Executive Committee Meeting

To: RVCA Executive Committee – Application Hearing
From: Nick Fritzsche, Section 28 Regulations Inspector
Terry Davidson, P.Eng., Director of Engineering and Regulations
Subject: Hearing of Application for Development – Ontario Regulation 174/06
Date: December 14, 2023

Application # RV3-59/23

File RV3-5923, Proposed Armor Stone Retaining Wall & Landscaping, 6079 James
Bell, Manotick, ON

A.04.8

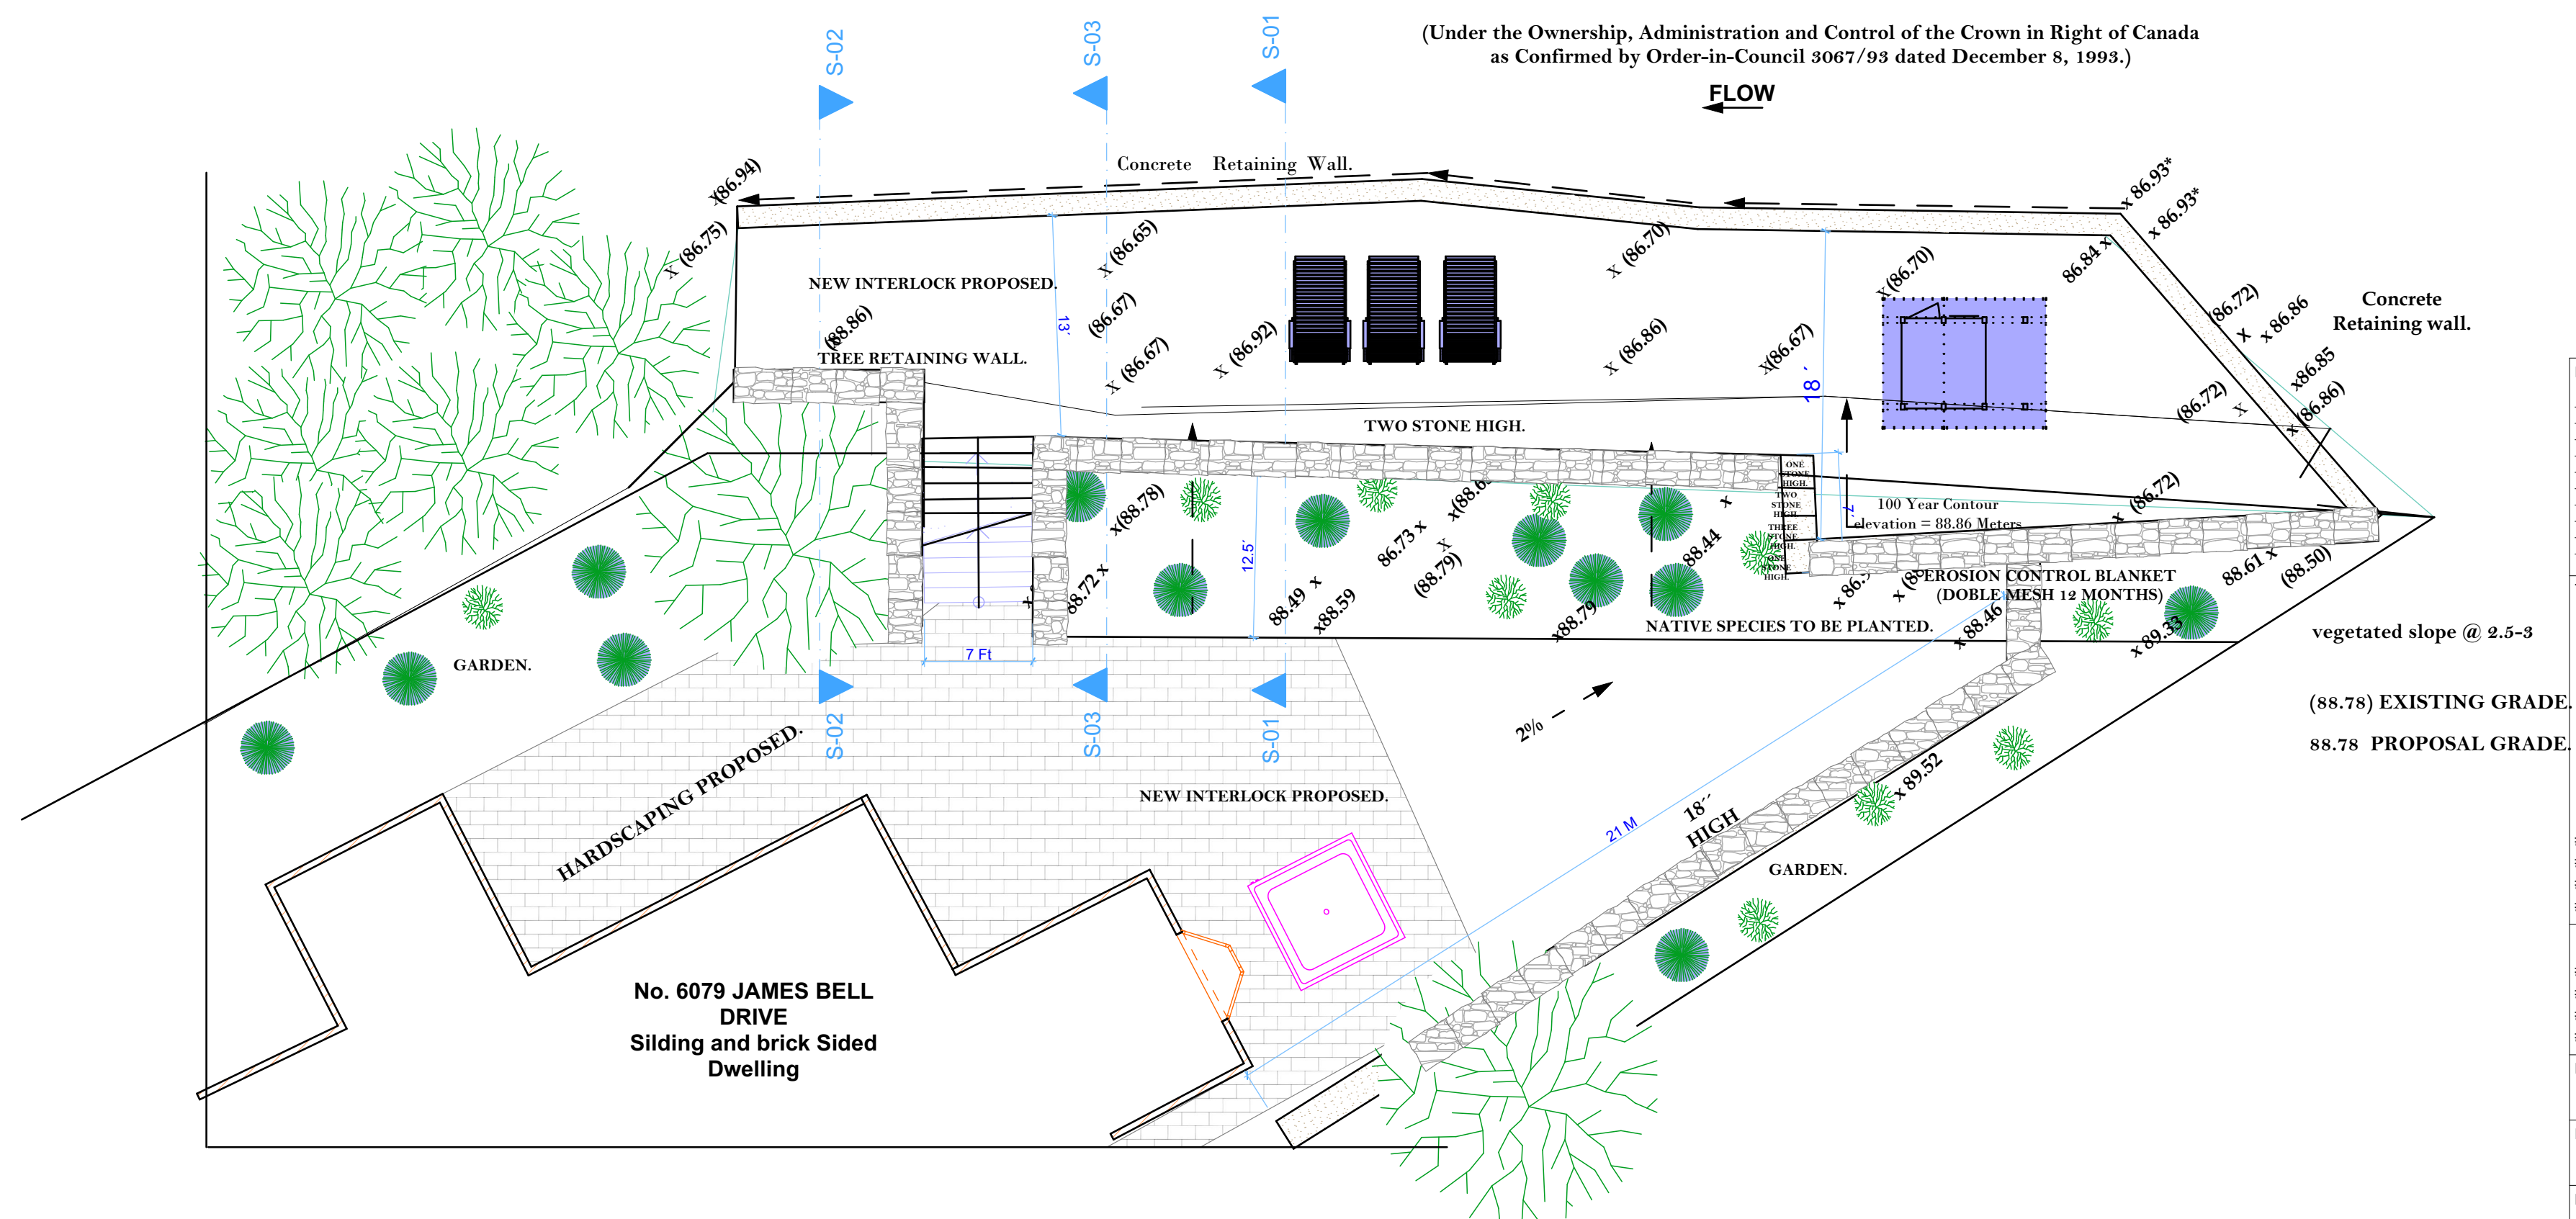
Current site alteration consists of the integration of armor stone retaining walls, some resloping and revegetation, as well as placement of interlocked pavers on top of the old concrete pad (Figure 3). We do not have photos of the final landscaping, but from the site plan addition of

interlocked paver is also proposed at the top of the slope in between the rear of the residence and crest of slope.

According to the applicant's provided drawings, the concrete pad level is at an elevation of 86.67 m (assuming it is a geodetic elevation, although this is not confirmed on the plan). The high water mark (HWM) is at 85.5 m, and the 100-year flood elevation is at 86.86 m. Consequently, only a minor amount of water would exceed the concrete pad elevation during a 100-year flood event. For further context a 100-year flood event has never been recorded on the Rideau River. This suggests that toe erosion is an unlikely cause for the site's past conditions, as the lower concrete structure provides the majority of the erosion protection. The observed minor erosion on the slope is most likely the result of natural degradation of the wooden retaining walls and runoff from precipitation. Considering the channel configuration, flow, operational water elevation, and projected 100-year flood event, constructing a hardscaping wall at the site to protect against toe or runoff surface erosion is not assessed to be necessary.

Furthermore, the use of interlocked pavers at the top of the slope may limit infiltration and induce uncontrolled runoff water from precipitation. It is recommended to implement stormwater control measures and reconsider their use to reduce the volume of runoff.

- More sustainable erosion mitigation techniques are feasible to be implemented at the site such as regrading, naturalization, or bio-engineering erosion mitigation techniques. These measures can help stabilize the slope and limit erosion risks without the need for a hardscape retaining wall.
 - Naturalizing the shoreline with appropriate vegetation can help control erosion and enhance the resilience of the slope.

- Bio-engineering techniques, such as using erosion control blankets or green retaining wall, can also be considered to mitigate erosion and promote slope stability (if required)
- Implementing and managing runoff water originating from the upper part of the slope, which appears to be the primary factor contributing to some of the surficial erosion observed damages.
- Implementing stormwater management techniques, such as installing permeable surfaces or rain gardens, can help capture and slow down runoff water, reducing its erosive potential. This would involve potentially reducing or revisiting the use of interlocked paver as this would increase the volume of runoff water originating from the top of the slope.
- The use of riparian buffers with appropriate native plants along the shoreline can help absorb and filter runoff water, preventing further erosion.

A.04.7

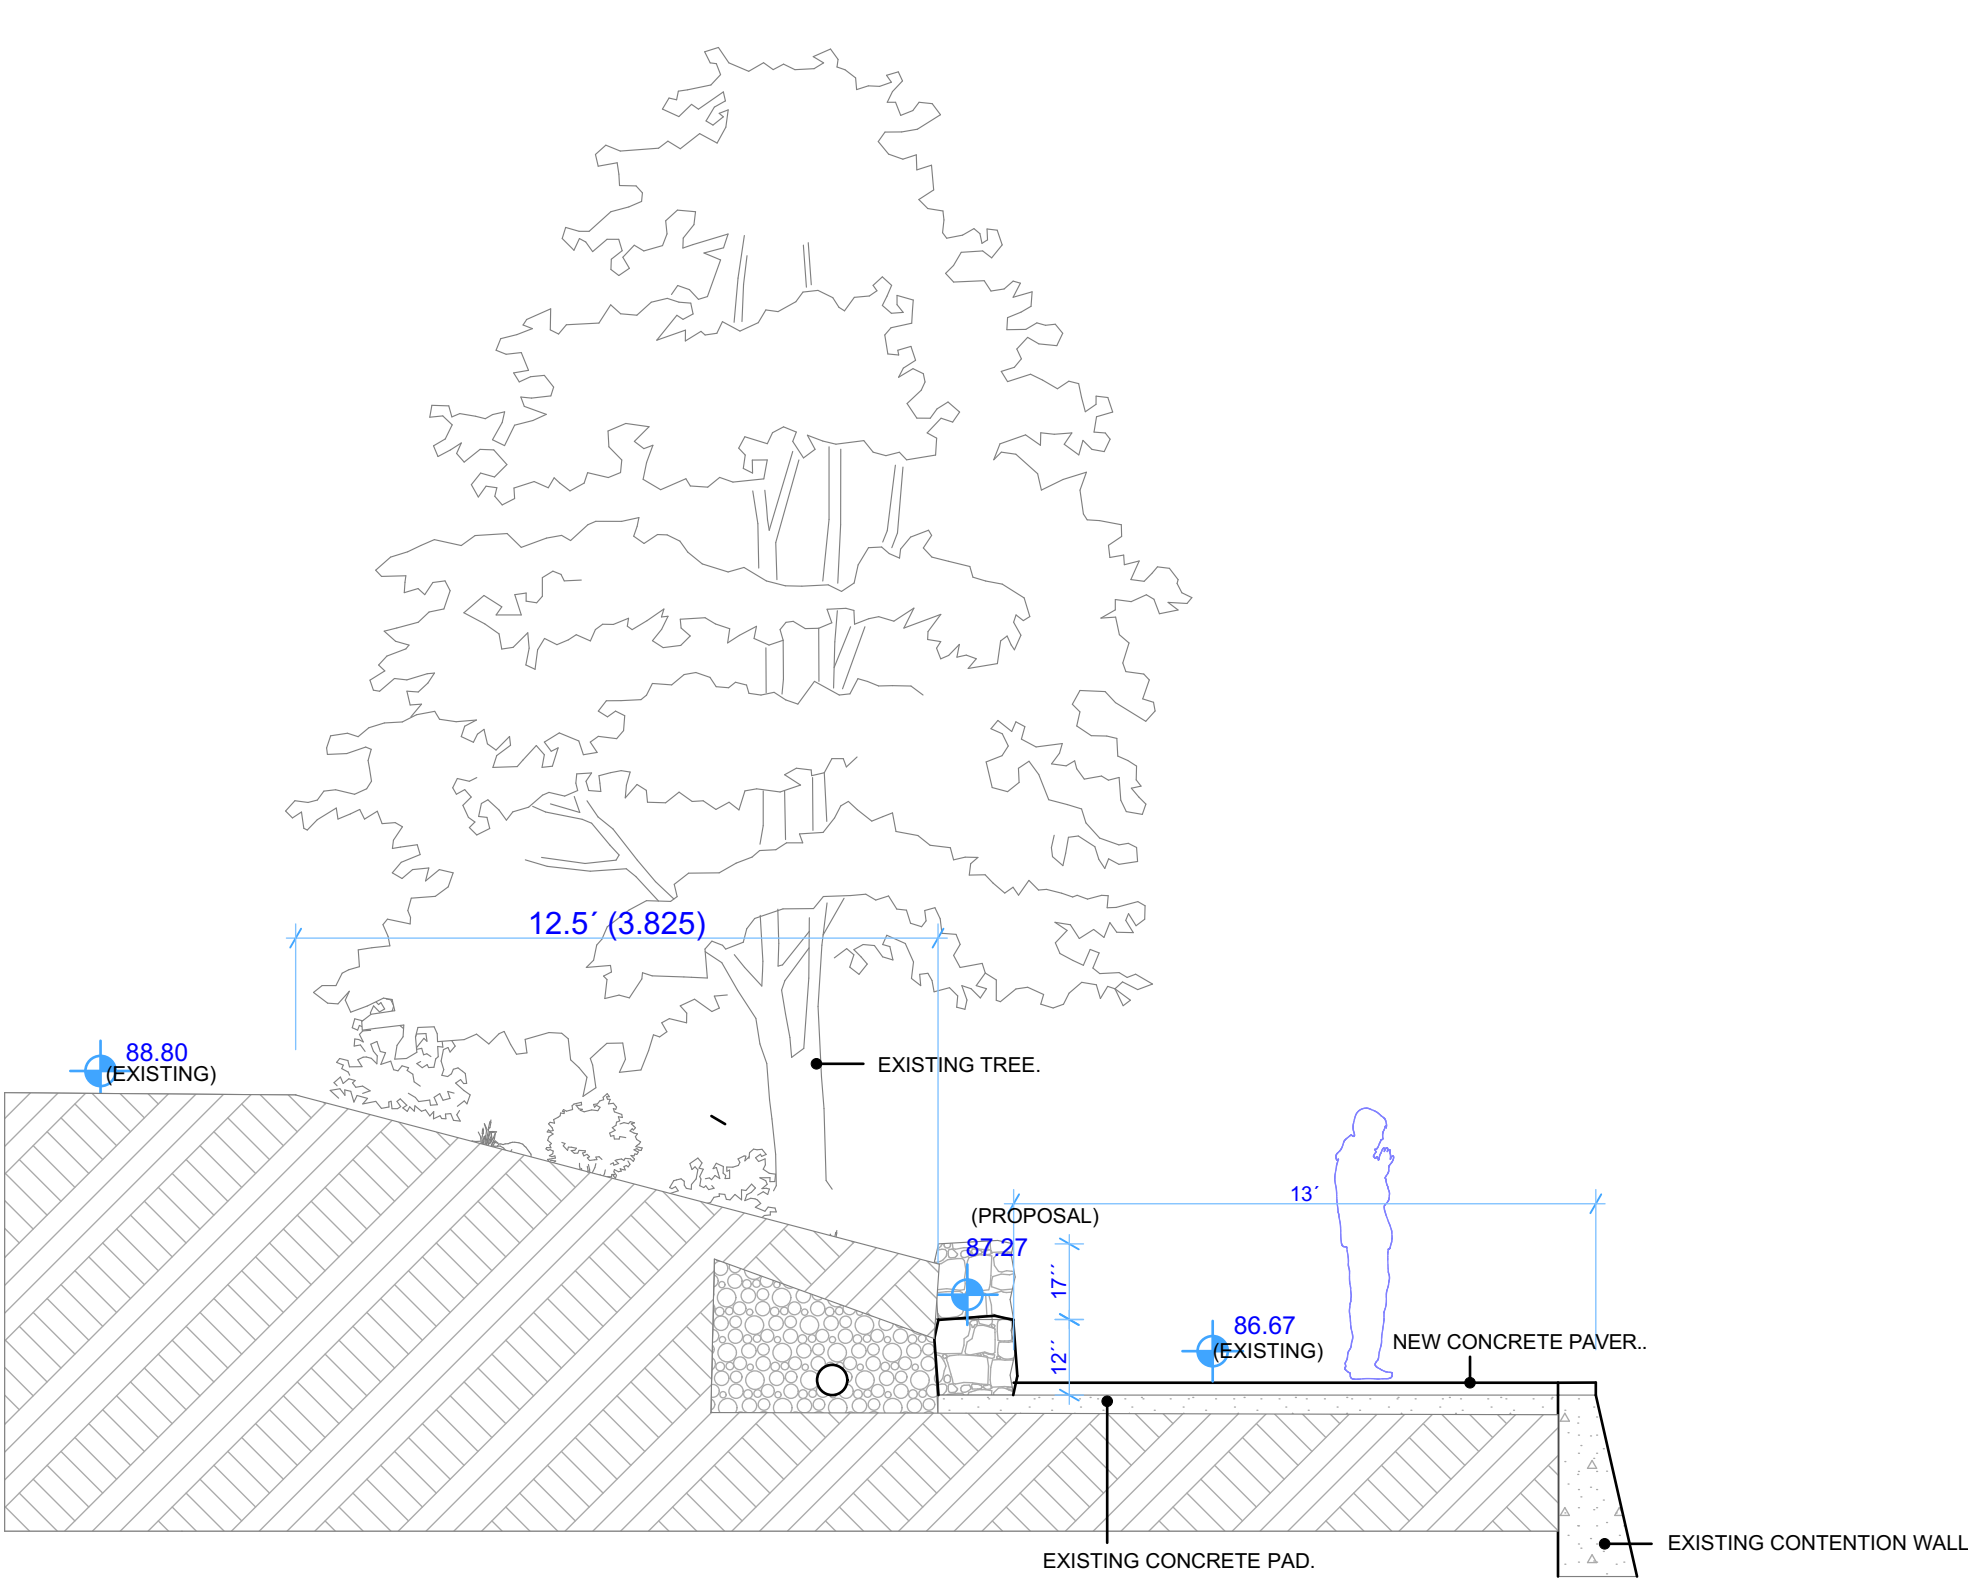
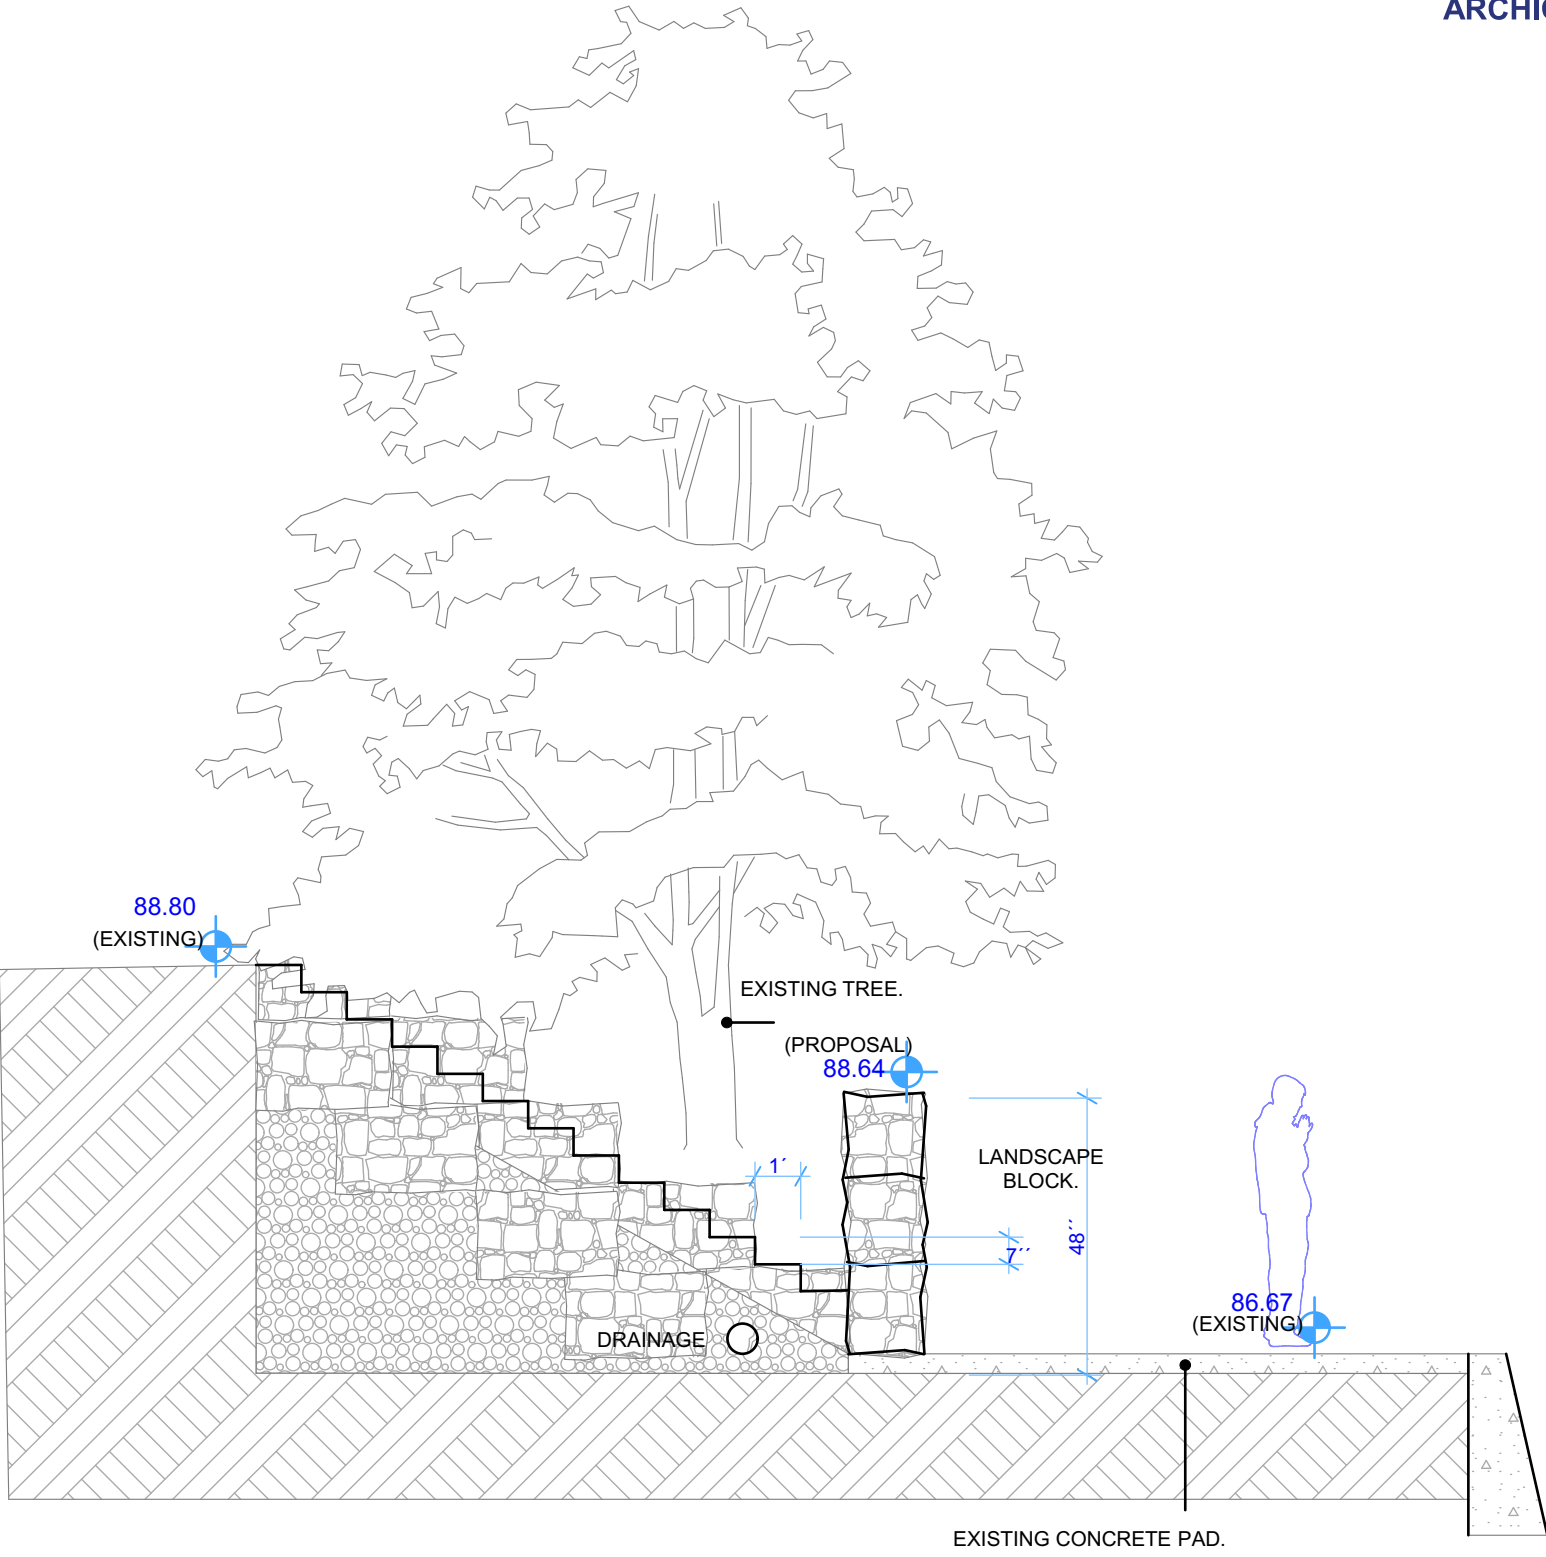
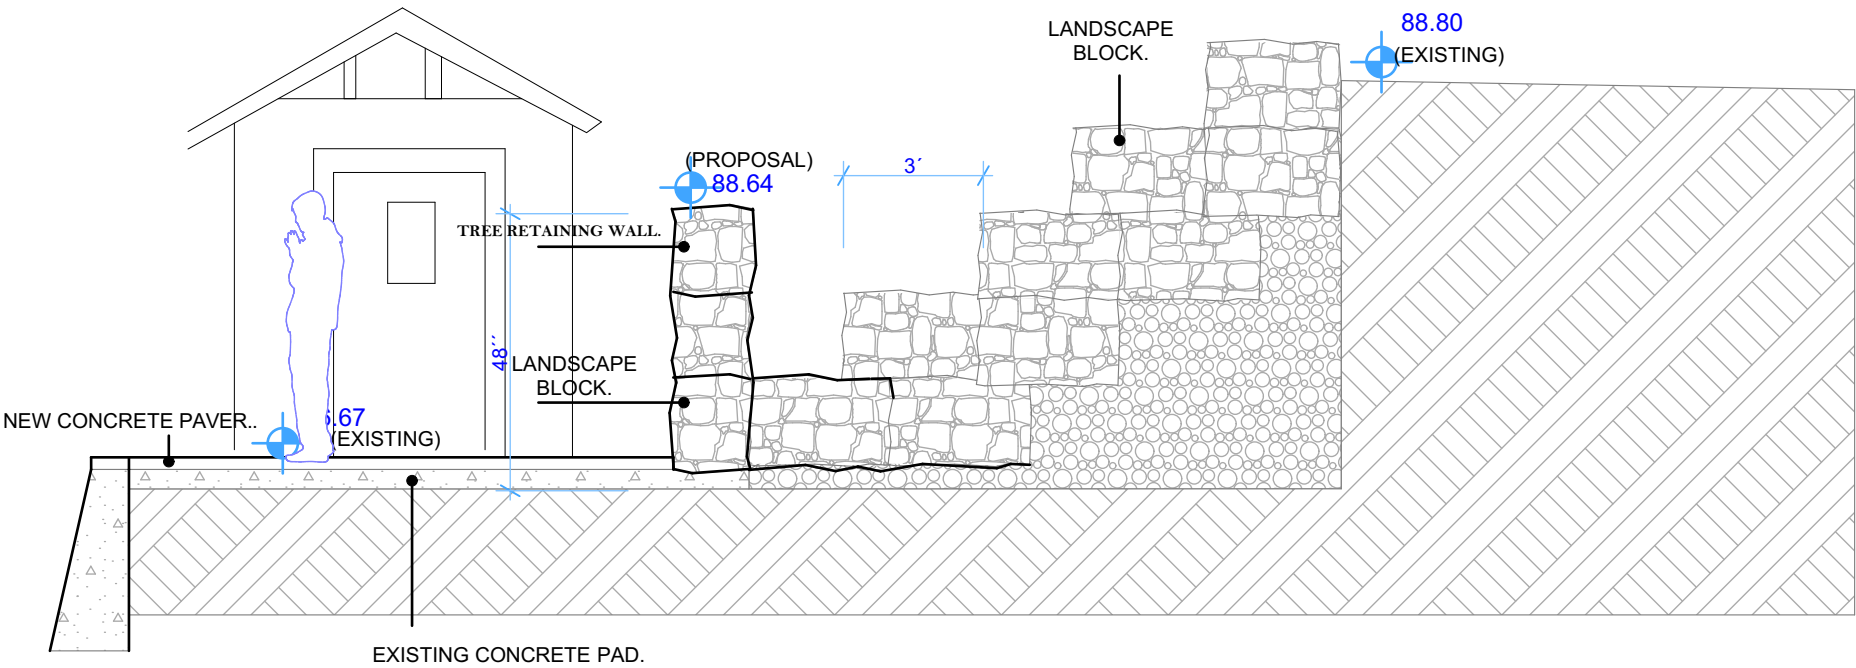
The armor stone wall is located above the concrete pad and vary in size between 2 to 4 block high.

Based on the available information provided and a review of local geotechnical conditions, we concluded based on our professional experience, that the slope in question does not require an armor wall for structural support. Several factors contribute to this assessment and are presented below:

- The slope has an overall (toe to top starting at concrete wall) inclination of about 18 degrees, with localized steeper sections.

- The height of the slope is below 5 meters, further reducing the risk of instability.
- Minor surficial erosion and weathering caused by runoff water have been observed, but they are not indicative of significant slope instability.
- The site itself can accommodate measures such as regrading, renaturalization, or bio-engineering erosion mitigation, which can effectively address these minor issues and limit the risk of instability.
- The current residence foundations are not reliant on the retaining structure and are sufficiently setback, ensuring that they would not be compromised by any instability or failure of the slope or retaining wall. This eliminates any significant risk to public safety that would warrant structural remediation (in this case a hardscape retaining wall).

Considering these factors, it appears that the retaining wall primarily serves a landscaping purpose, and its role in providing structural support to the slope is not necessary.

Based on the preliminary evaluation of the slope stability and erosion hazards at the site from a geotechnical perspective, we conclude that the use of a hardscape retaining wall was not required. The foundation to support our recommendations are summarized below:
